SUBJECT: Discusses emergency lighting in control room. Overhead emergency lighting sys uses non-Class 1E fixtures & dimmers. In event of failure of tubes or dimmers following seismic event, 8 h battery pack lighting operable. Diagram encl.

Re: Nine Mile Point Unit 2
Docket No. 50-410

FIGURE 1.2-15
GENERAL ARRANGEMENT
CONTROL ROOM PLAN
EL. 306'-0" SHEET 1 OF 3
NIAGARA MOHAWK POWER CORPORATION
NINE MILE POINT-UNIT 2
FINAL SAFETY ANALYSIS REPORT

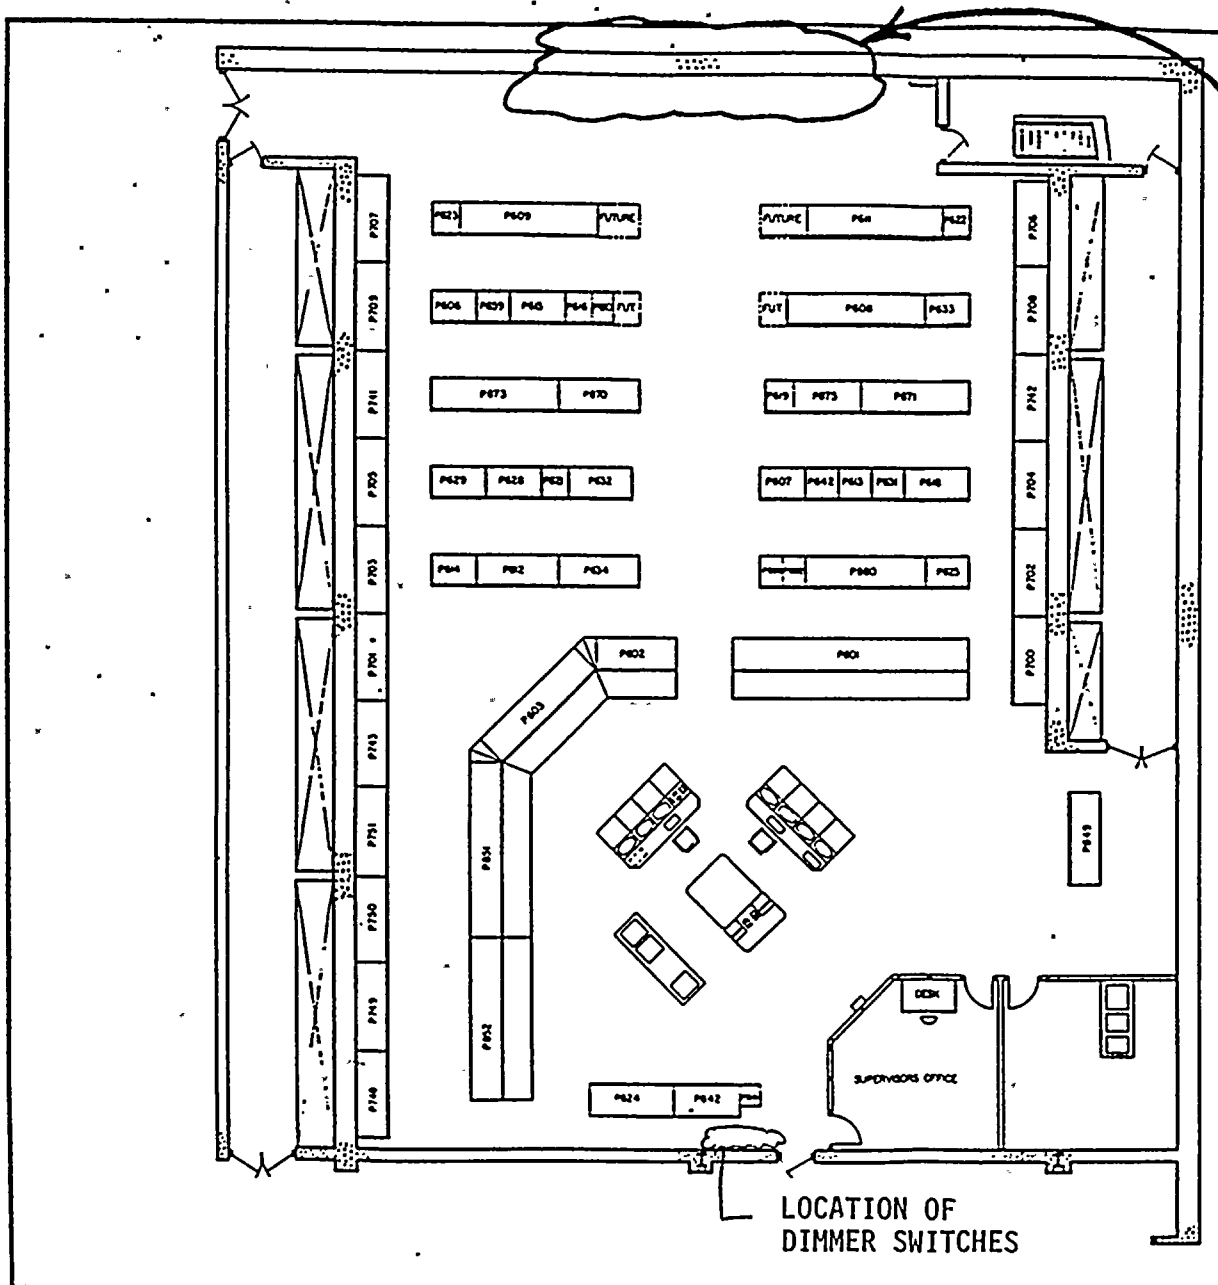
This letter addresses a concern raised by a Nuclear Regulatory Commission staff member pertaining to the emergency lighting in the Nine Mile Point Unit 2 Control Room. The overhead emergency fluorescent lighting system uses non-Class 1E fixtures and dimmers similar to those used in other nuclear power plants. Class 1E devices are not available. In the event of the failure of tubes or dimmers following a seismic event, the eight hour battery pack lighting would take over the Control Room lighting function. Before the battery pack lighting becomes inoperative, Niagara Mohawk could restore the emergency fluorescent lighting to meet or exceed the illumination levels specified in the Illumination Engineering Society Handbook as required in Standard Review Plan 9.5.3. The location of the dimmer panels is shown on the attached markup of the Final Safety Analysis Report Figure 1.2-15. The fluorescent light fixtures are located in the Control Room overhead.
